Access Compliance Report

Public Rights-of-Way

(Curb Ramps)

Intersection ID: 12508	Main Street: BELVEDERE_AV	Cross Street: CLUB_RD	Location: E
ADA ID: 3FD9344E2ED6	Ramp Type: Perp	Initial Pass/Fail: Fail	Overall Compliance: No
Codes/Mitigation Info/Possible Solution		Field Measurements/Component Compliance

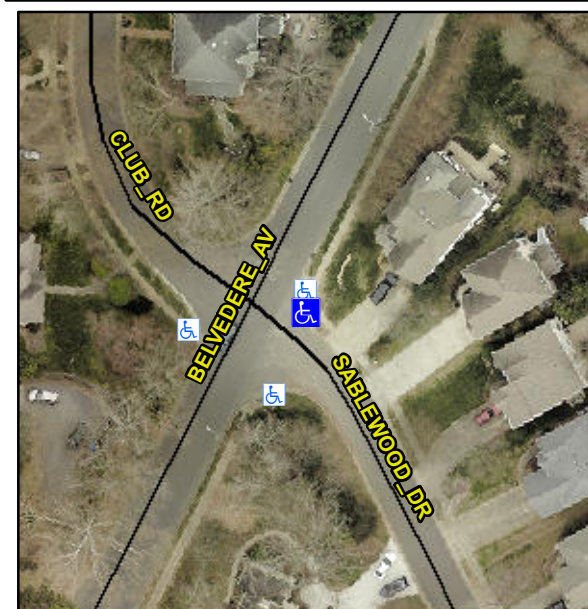
Not Found, R304.2.2, R304.5.3

Compliance	Description	Data	Compliance	Description	Data
N/A	Ramp Length (in)	49.0	No	Ramp Slope (%)	8.6
Yes	Ramp Width (in)	75.0	No	Ramp XSlope (%)	4.7
N/A	Flare Type LT	N/A	N/A	Flare Type RT	N/A
N/A	Flare Slope LT (%)	N/A	N/A	Flare Slope RT (%)	N/A
N/A	Flare Traversable LT?	N/A	N/A	Flare Traversable RT?	N/A
N/A	Landing Length (in)	N/A	N/A	DWS Provided?	N/A
N/A	Landing Width (in)	N/A	N/A	DWS Contrast?	N/A
N/A	Landing Slope (%)	N/A	N/A	DWS Length (in)	N/A
N/A	Landing X Slope (%)	N/A	N/A	DWS Full Width?	N/A
N/A	Landing Curb? (Y/N)	N/A	N/A	DWS Offset (in)	N/A
N/A	Shared Landing?	N/A			
N/A	Gutter Ponding?	N/A	N/A	Gutter Slope (%)	N/A
N/A	Gutter Lip Ht (in)	N/A	N/A	Gutter X Slope (%)	N/A
N/A	Painted X Walk1?	No	N/A	Painted X Walk2?	N/A
	X Walk 1 Direction	To SW		X Walk 2 Direction	N/A
N/A	X Walk 1 Width (in)	N/A	N/A	X Walk 2 Width (in)	N/A
	X Walk 1 Slope (%)	4.2		X Walk 2 Slope (%)	N/A
	X Walk 1 X Slope (%)	1.2		X Walk 2 X Slope (%)	N/A

Remove & Replace Entire Ramp.
